# Submissions Report

Redfern Place – 600-660 Elizabeth Street, Redfern

SSD-51274973

**Figure 2 Buildings S3 and S4 addendum windowsill heights**

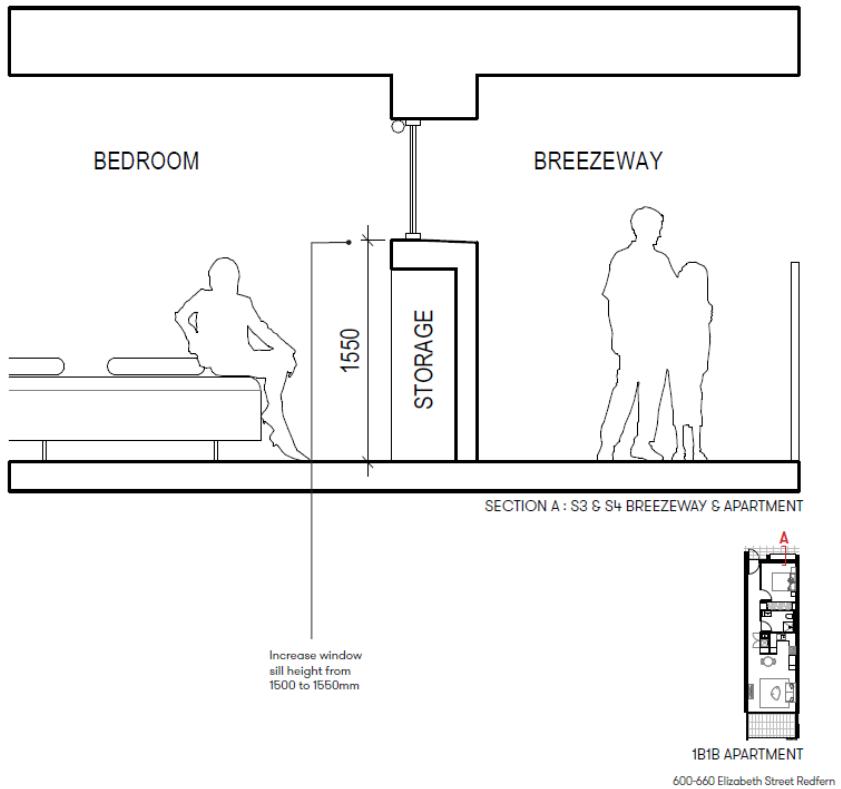
In response, the bedroom windowsill heights for Buildings S2, S3, and S4 have been increased from 1,500mm to 1,550mm (refer to **Figure 2** and **Figure 3**). Ground floor studios in Building S2 will retain a sill height of 1,200mm to ensure adequate natural light and ventilation. For Building S2, an external shelf will be maintained at 1,200mm to allow for personalised treatments, such as pot plants, which contribute to soft separation and resident ownership of the space.

**Figure 5 Extract of Level 1-3 plan showing proposed hooded window treatment interfacing with breezeway**

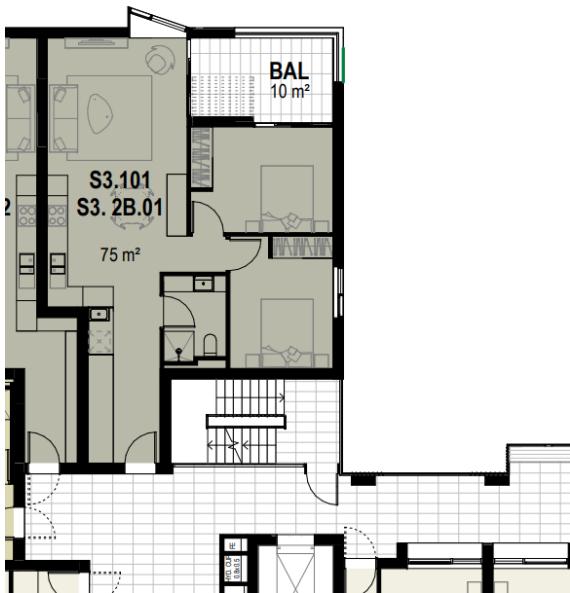
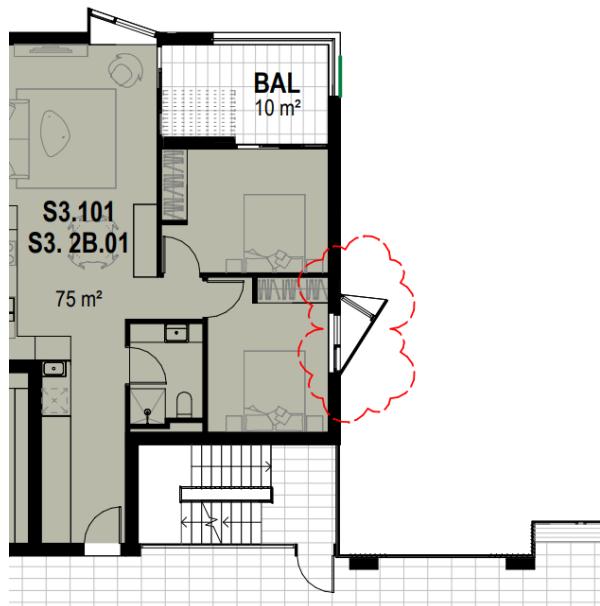
Window hoods have been introduced to a bedroom window fronting the central courtyard on the southern wing of the S3 building (Levels 1-3). The window hood will provide greater privacy from potential overlooking from the S3 breezeway. A comparison between the lodged and amended window treatment is provided in **Figure 4** and **Figure 5**.

**Figure 6 Shade structures (clouded in red)**

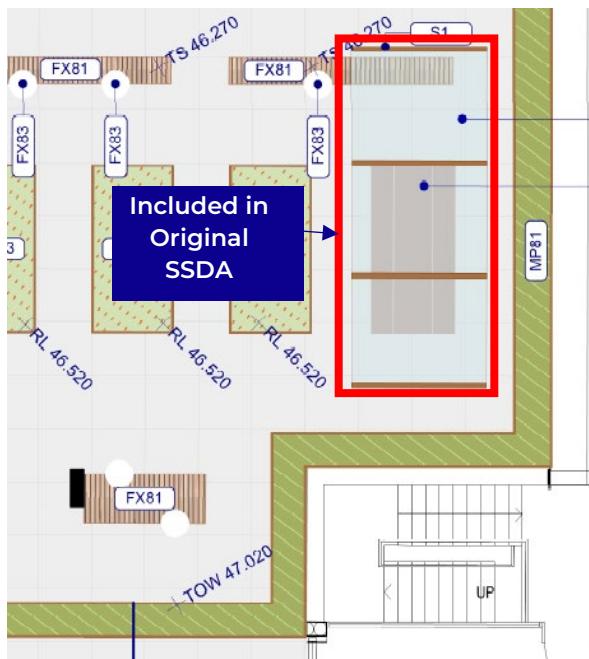
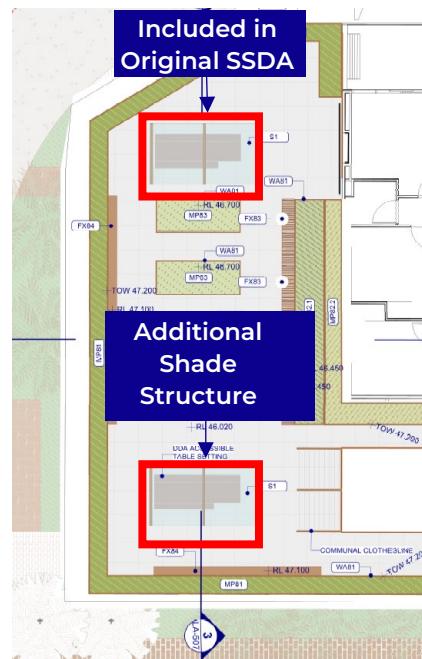
Council noted that limited shade was provided in the rooftop communal open spaces on Buildings S3 and S4.

The submitted SSDA design included a large shade structure on Building S3 and one shade structure on Building S4 (as shown in **Figure 6**). To respond to Council's comment, an additional fixed shade shelter has been incorporated on the eastern portion of the rooftop of Building S4 (as shown below in **Figure 6**).

**Figure 8** Excerpts of lodged and revised Basement Level floor plan

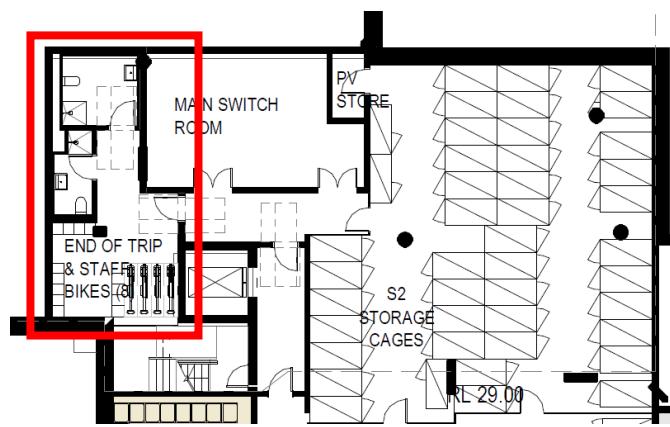
Council recommended that end of trip facilities be provided including two (2) shower and change cubicles and 13 person lockers for staff.

Further, Council also requested the bicycle parking provided for the entire site comply with AS2890.3, noting some bicycle lockers appear undersized (depth) and would not be able to securely accommodate bicycles.

In response, end-of-trip facilities have been included within the revised basement plan (as shown in **Figure 8**). The facilities now include two (2) shower and change cubicles and 13 personal lockers for staff.

Bicycle parking within the basement level has been revised to comply with relevant Australia Standards, addressing concerns regarding the depth of lockers. The updated layout now accommodates 355 bicycle spaces for residents and eight (8) for staff. An annotated plan showing the storage cages and bike racks is provided in the Design Report Addendum at **Appendix E**.

**Figure 9 Annotated revised basement plan**

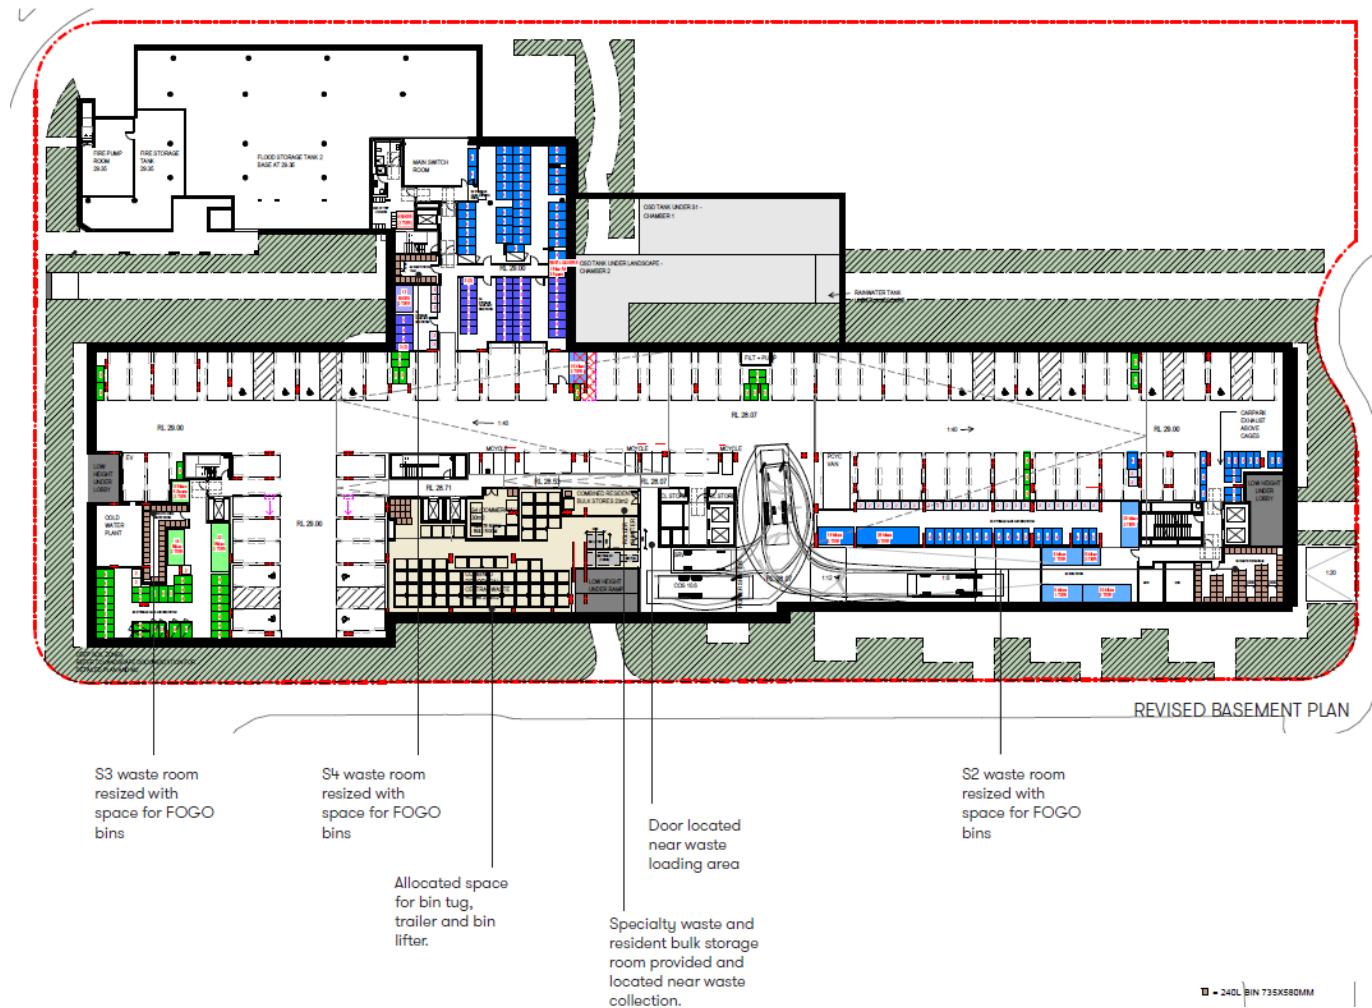
Council Request	Response
within Reference A of the guidelines. S2, S3 and S4 residential waste rooms are to be adequately sized to provide two days storage of waste in 240L bins.	240L bins. Refer to the Basement Level floor plan provided at <b>Appendix C</b> . An annotated Basement Level floor plan is provided below in <b>Figure 9</b> .
The location and space allocated for waste and recycling bins including the required number of bins drawn to scale (240L, 1,100L) and proposed layout within waste storage areas.	Provided. Refer to the Basement Level floor plan provided at <b>Appendix C</b> . An annotated Basement Level floor plan is provided below in <b>Figure 9</b> .
In line with Greenstar objectives, provide a dedicated space for food organic bins and a resident accessible space for the collection of tricky to recycle items collected as part of Councils Doorstep Recycling service.	Designated areas have been allocated for food organics (FOGO) bins. An annotated Basement Level floor plan is provided below in <b>Figure 9</b> that shows the proposed location of FOGO bins.

**Figure 11 Accessible pathways to bike storage in basement (outlined in blue)**

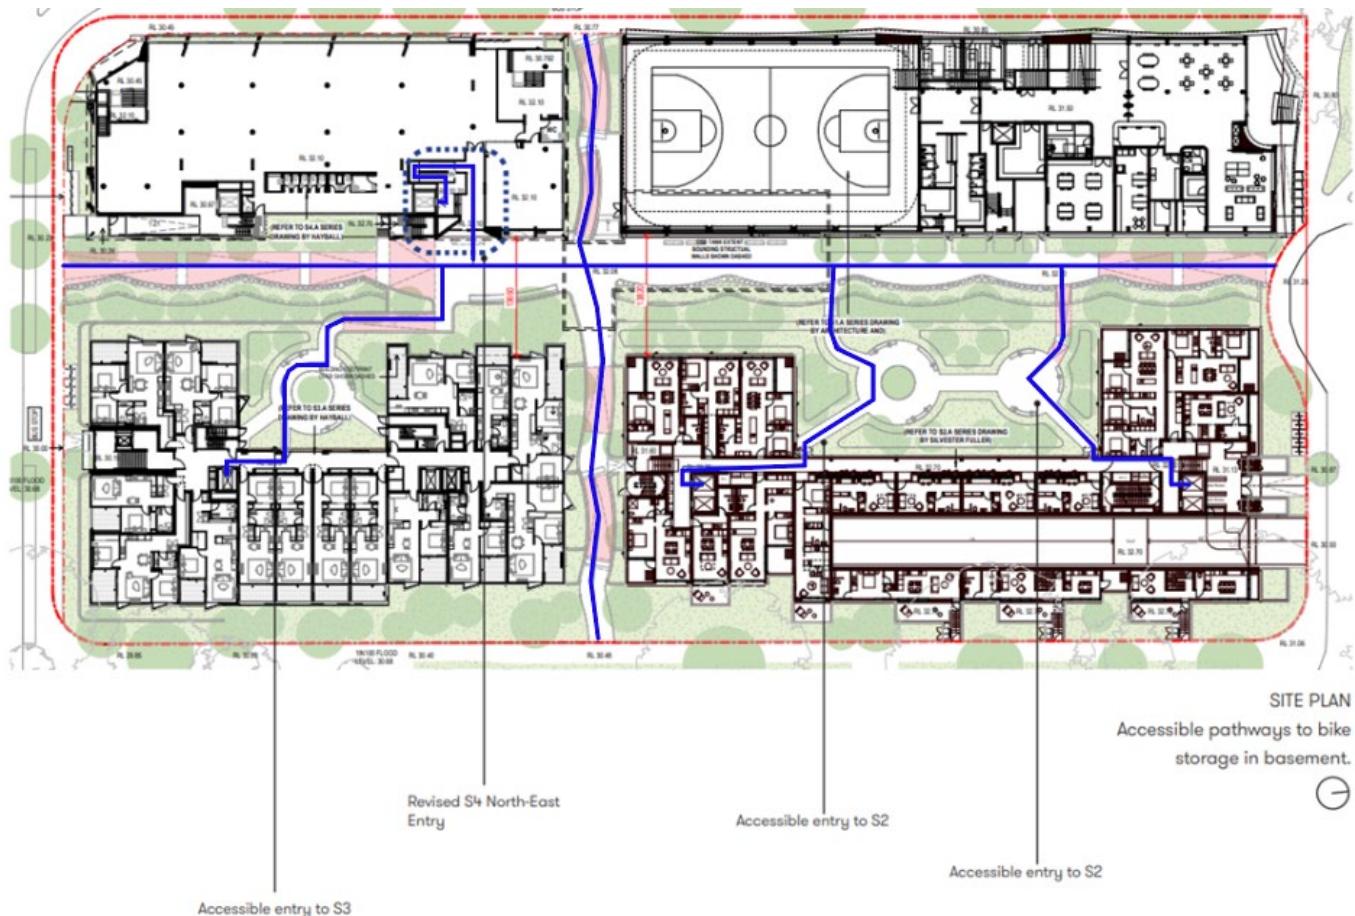
Accessible paths of travel (with a bicycle) are identified in **Figure 11** and provided in the Design Report Addendum at **Appendix E**. As noted in the Transport Letter prepared by Ason at **Appendix R**, all access paths to and from lobbies provide travel path widths between 1.6m and 1.9m and comply with the minimum access path widths as detailed in AS2890.3:2015. The Building S4 northeast lobby has been redesigned to improve ramp access to the lift, ensuring access for all users, including Bridge workplace occupants, Building S4 residents, and PCYC staff. Additionally, the lobby has been raised to align with the level of the community lounge, improving access to key shared areas such as the reception, interview rooms, and the community room. These revisions are illustrated in the revised Ground Level floor plan (extract provided at **Figure 12**).

**Figure 13 Additional flood storage underneath Building S4**

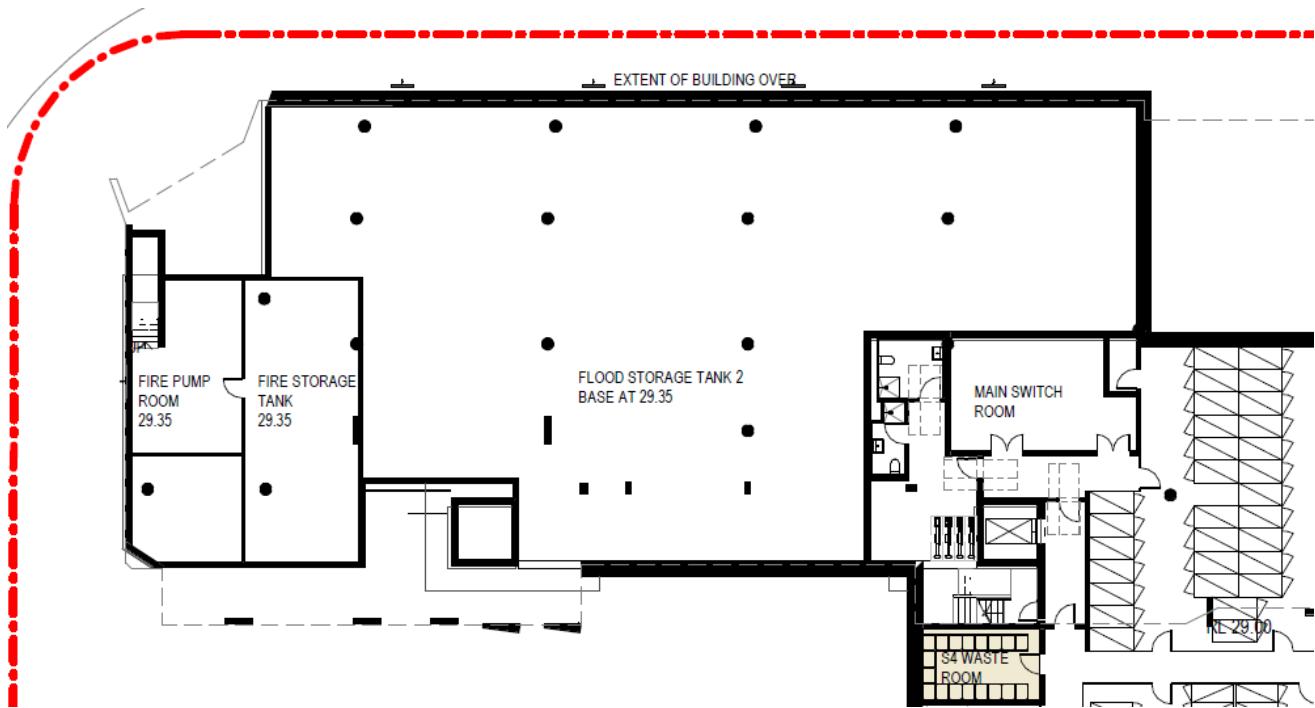
Please revise flood mitigation strategies to address risks of water ingress, drainage challenges, litter accumulation, and maintenance and safety hazards.	The flood storage tank will also take flood water from the corner of Kettle St and Walker St. This will be captured using pits and conveyed to the flood storage tank under Building S4 through a Reinforced Concrete Pipe that will run under Building S1. Refer to <b>Figure 14</b> .
On-site detention (OSD) and stormwater treatment partially located in the basement rely on a drowned outlet for drainage, raising concerns about effectiveness and compliance. The Effectiveness of onsite detention should be assessed by Sydney Water and/or Council officers.	Updated flood modelling has been undertaken in <b>Appendix J</b> , incorporating the amended flood mitigation measures. Compared with the existing flood behaviour, there is no increase in the levels of inundation or the flood hazard in neighbouring properties. There are some highly localised areas of increase within the site boundary and the road reserve, however internal to the site the flood behaviour is managed holistically across the site and includes a Flood Emergency Response Plan. The changes within the road reserve are extremely localised and do not alter the flood functionality of the roads.

**Figure 15 Evacuation route**

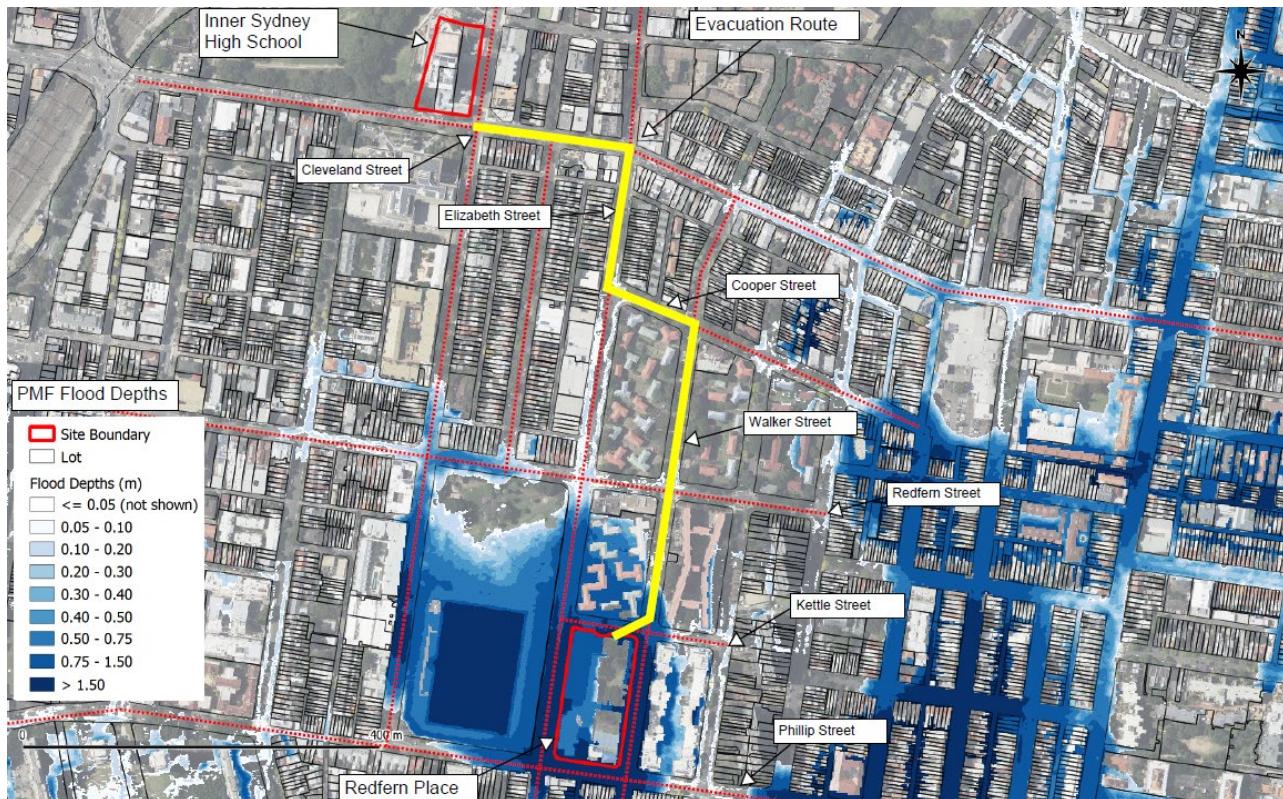
DCCEW and Council requested a comprehensive flood emergency response plan be developed to assess emergency issues related to storms up to and including the PMF. DCCEW also noted that one residential unit lacks access to shelter above the PMF level.

In response, the floor level of all residential apartments on Walker Street have been lifted to RL32.7 to be above the PMF, ensuring the residents can safely shelter in place if required, with full access to their entire homes provided (noting previously the levels of three terraces with access from Walker Street were positioned below the PMF). In doing this, all residences are now located completely above the PMF to safely shelter in place without risk of damage to life or property.

Flood Emergency Response Plans (FERPs) have been prepared for the residential component, Building S1 (PCYC) and the commercial uses (refer to **Appendix L**). All FERPs confirm there is an evacuation path through the site to Kettle Street and onwards towards the Inner Sydney High School that has a flood hazard classification of H1 (generally safe for people, vehicles) in events up to and including the 0.2% AEP event (refer to **Figure 15**). In storms larger than the 0.2% AEP event such as the Probable Maximum Flood (PMF) a Shelter-in-Place strategy is adopted due to the faster rate of rise of flood waters that occurs surrounding the development. The fastest rate of rise occurs at the southern end of Walker Street and Phillip Street where it takes approximately 12 minutes for flood depths to reach 0.5m and 20 minutes for flood depths to reach 1.2m. Given the rate of rise, evacuation during events such as the PMF is not feasible, particularly for vulnerable tenants who may have mobility impairments.

**Figure 16 Comparison of lodged and revised fire pump room arrangement**

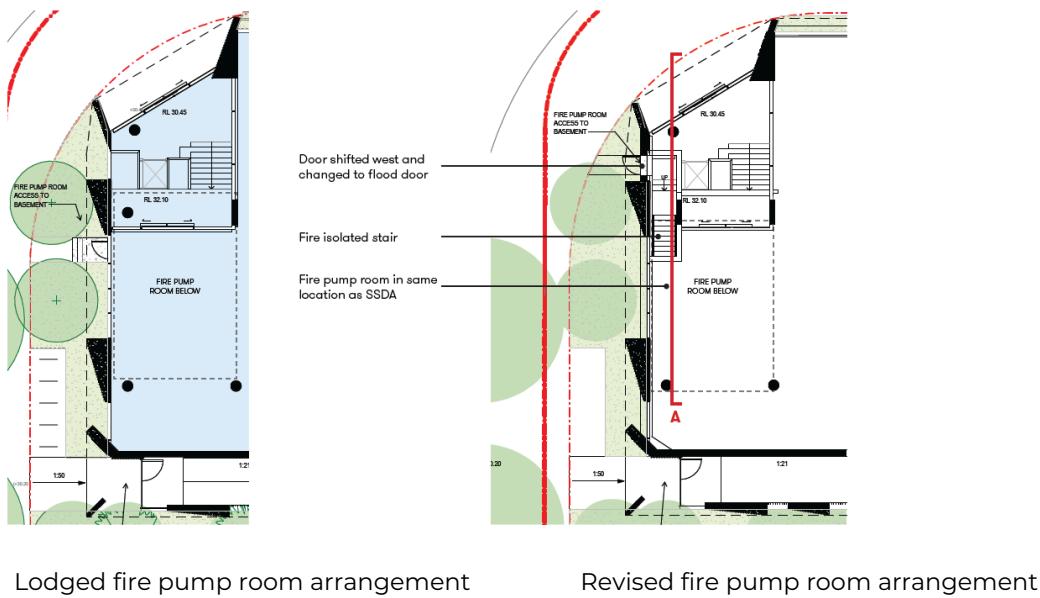
In response, to ensure the room is protected in a 1% AEP flood event, the fire pump room entry stairs have been relocated and a flood door has been introduced located at the 1% AEP flood level, noting access is not required to the fire pump room during a flood event. A comparison of the submitted and revised fire pump room arrangement is provided in **Figure 16**. Further detail is provided in the Design Report Addendum at **Appendix E**.

**Figure 18 Comparison of lodged Walker Street arrangement (top) and revised Walker Street arrangement with retained tree (bottom)**

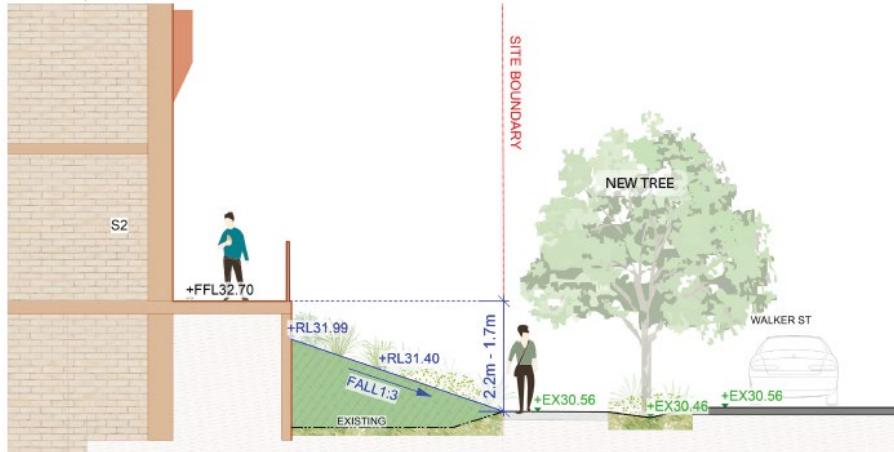
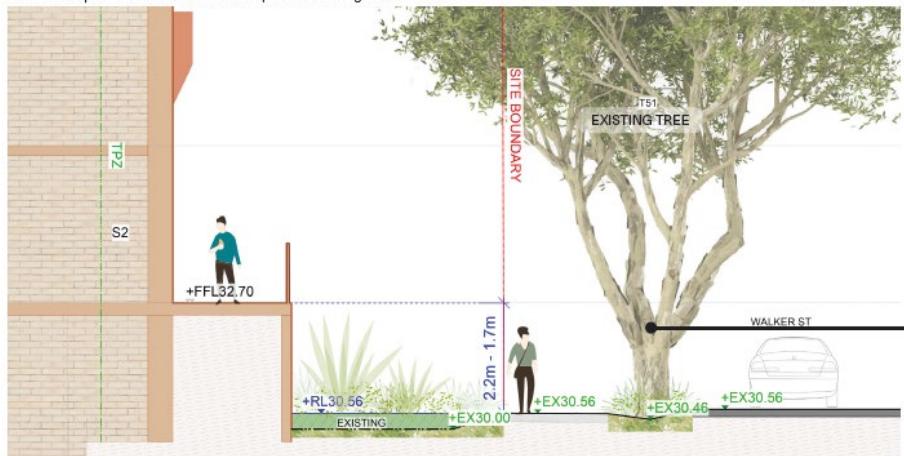
In response, the Applicant engaged Lee Hancock Consulting Arborist to provide a peer review of the Arboricultural Impact Assessment that was prepared by Ecological Australia and was submitted with SSD-51274973. The review was undertaken to assess the potential to retain the four (4) *Melaleuca quinquenervia* (Paperbark) trees numbered T51, T52, T53 and T54 located on Walker Street (identified in **Figure 17**). The review confirmed that the trees could be retained given the resilience of the species noting they are typically subject to high levels of root disturbance/loss from footpath and kerb works. While the TPZs relating to Trees T51, T52 and T54 were found to be impacted by terrace elements and landscaping works to varying degrees, the Arborist Statement confirms the trees should be retained without any changes to the built form. In response to the advice provided, the Walker Street landscaping has been updated to reduce mounding and provide for understory planting to minimise the impact on the trees. A comparison of the originally proposed and amended Walker Street landscaping treatment is provided at **Figure 18**. Further detail provided in the Landscape Drawings addendum and Landscape Design Report addendum.
